**PLANNING DRAWINGS**

DRAWING TITLE: <b>PROPOSED FIRST FLOOR PLAN</b>		
JOB DESCRIPTION: <b>CANON HALL PARK - STABLE BLOCK</b>		
DRAWING SCALE: <b>1:50 @ A1</b>	DATE: <b>JUNE 2019</b>	DRAWING REF: <b>2645.07B</b>
<b>BAART HARRIES NEWALL</b> <b>ARCHITECTS</b>		
<small>1 WILDERHOPE HOUSE FOURTH FLOOR BELLE Vue SHREWSBURY ST3 7JU Fax: 01743 346944 Tel: 01743 341261</small>

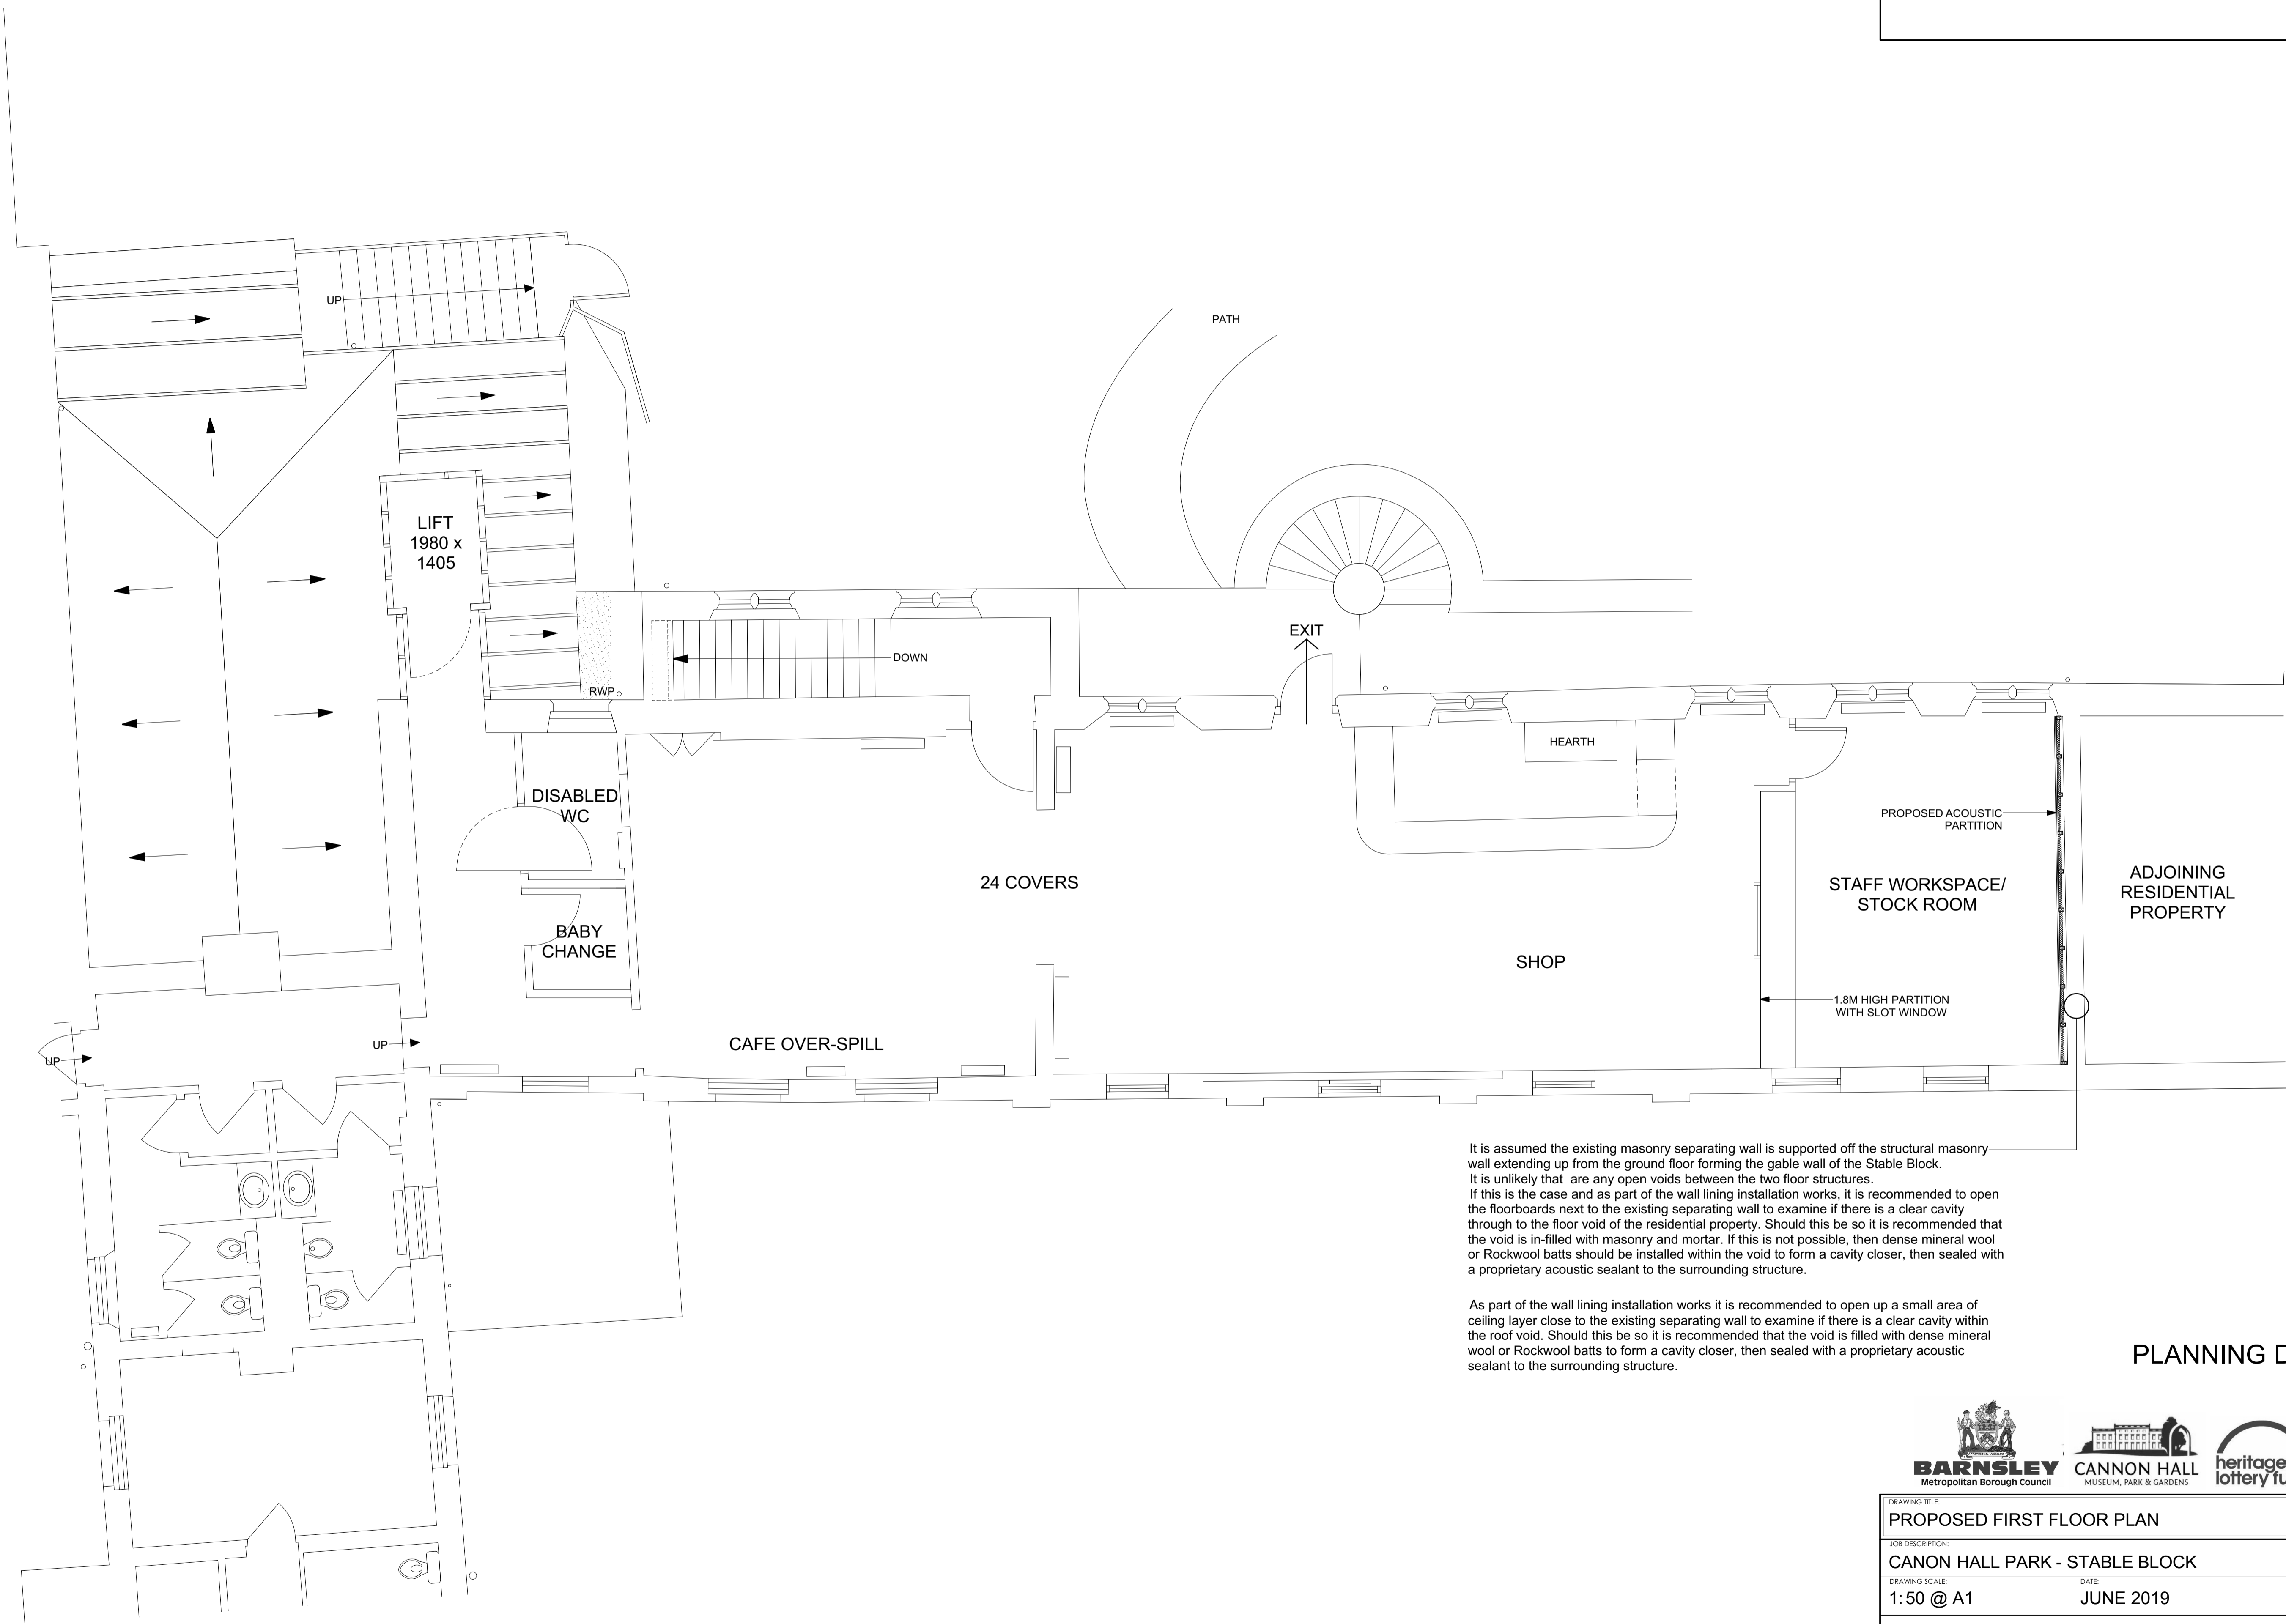
REVISION	DATE	DESCRIPTION
A	10.09.2020	ACOUSTIC SEPARATION PARTITION ADDED TO EXISTING WALL BETWEEN WORKSPACE ROOM AND ADJOINING RESIDENTIAL PROPERTY
B	03.11.2020	NOTES REGARDING PROPOSED ACOUSTIC RECOMMENDATIONS ADDED TO PLAN

It is assumed the existing masonry separating wall is supported off the structural masonry wall extending up from the ground floor forming the gable wall of the Stable Block. It is unlikely that there are any open voids between the two floor structures. If this is the case and as part of the wall lining installation works, it is recommended to open the floorboards next to the existing separating wall to examine if there is a clear cavity through to the floor void of the residential property. Should this be so it is recommended that the void is in-filled with masonry and mortar. If this is not possible, then dense mineral wool or Rockwool batts should be installed within the void to form a cavity closer, then sealed with a proprietary acoustic sealant to the surrounding structure.

As part of the wall lining installation works it is recommended to open up a small area of ceiling layer close to the existing separating wall to examine if there is a clear cavity within the roof void. Should this be so it is recommended that the void is filled with dense mineral wool or Rockwool batts to form a cavity closer, then sealed with a proprietary acoustic sealant to the surrounding structure.
